July 6, 2016 #7 / August 1, 2016 Item #9  
DEPARTMENT OF COMMUNITY SERVICES  
PLANNING DIVISION  
TOWN OF WEST HARTFORD  
50 SOUTH MAIN STREET  
WEST HARTFORD, CT 06107-2431  
TEL: (860) 561-7555 FAX: (860) 561-7504  
[www.westhartford.org](http://www.westhartford.org)

PERMIT APPLICATION FOR INLAND WETLANDS & WATERCOURSES  
ACTIVITY: (check one of the following)

Street Address of Proposed Application: 114 Waterside Lane

Brief Description of Proposed Activity: Installation of an in-ground salt water swimming pool  
Approximately 22' x 36'

114 Waterside Lane

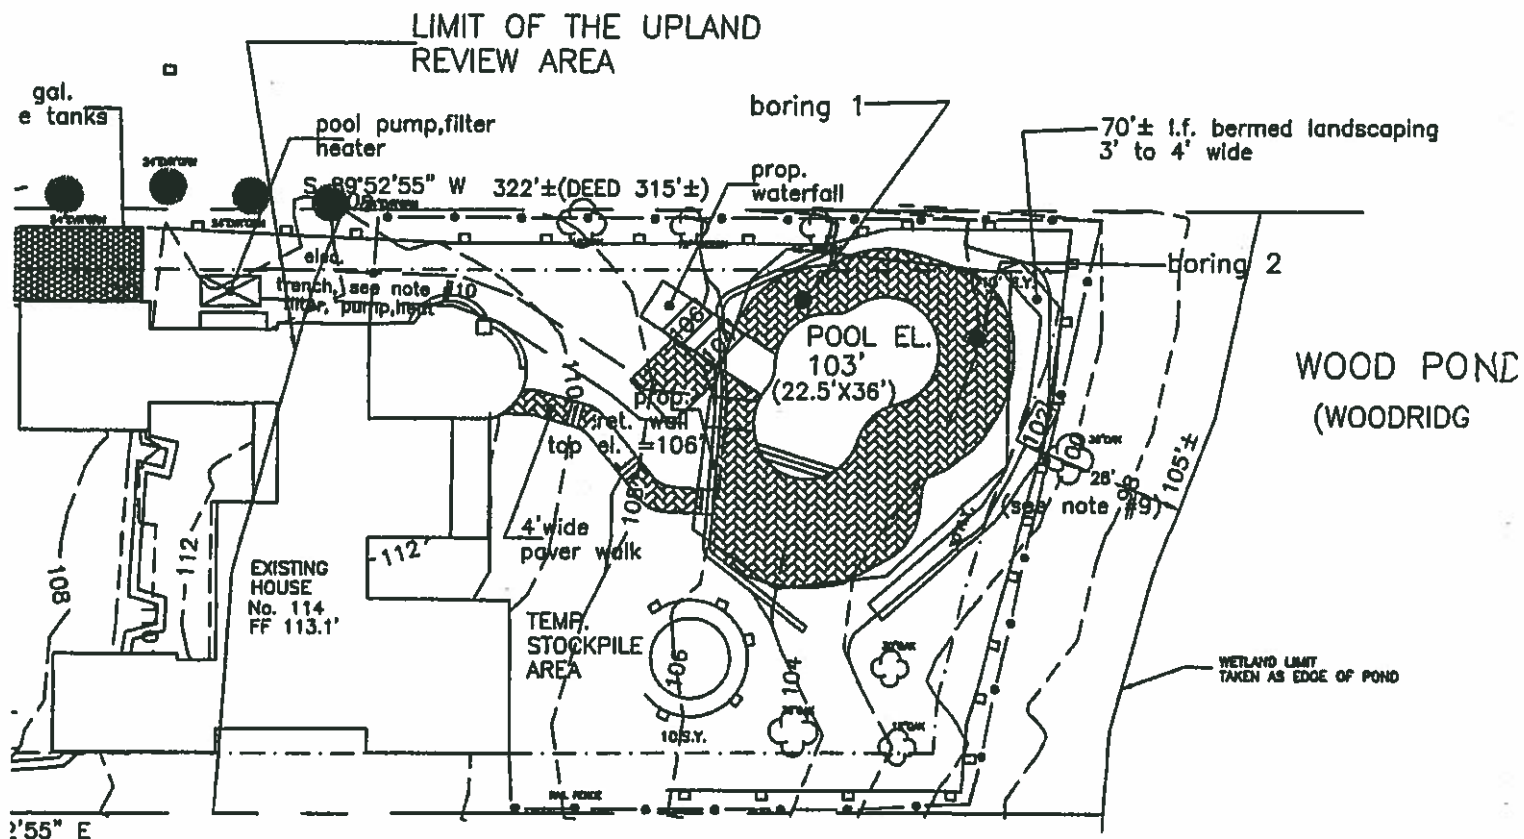
The purpose of this letter is give the results if testing for ground water levels at the location of the proposed pool as shown on the accompanying sketch for the proposed pool at 114 Waterside Lane.

Two borings were made and 1" perforated PVC satndpipes were installed on 7-7-16.

Readings for groundwater were taken the following day with the results posted on the attached sketch.

Excavation for the pool is expected to be 8.5' to 9.0'. Even with a small overdig, groundwater should not impose a consideration with the pool excavation/construction.

Boring 1	Boring 2
ground el.	104'	102'
depth of boring	8.5'	10.0'
depth to ground water	dry	8.5'
el. ground water	-	93.5'
pool excav. el.	94'	94'
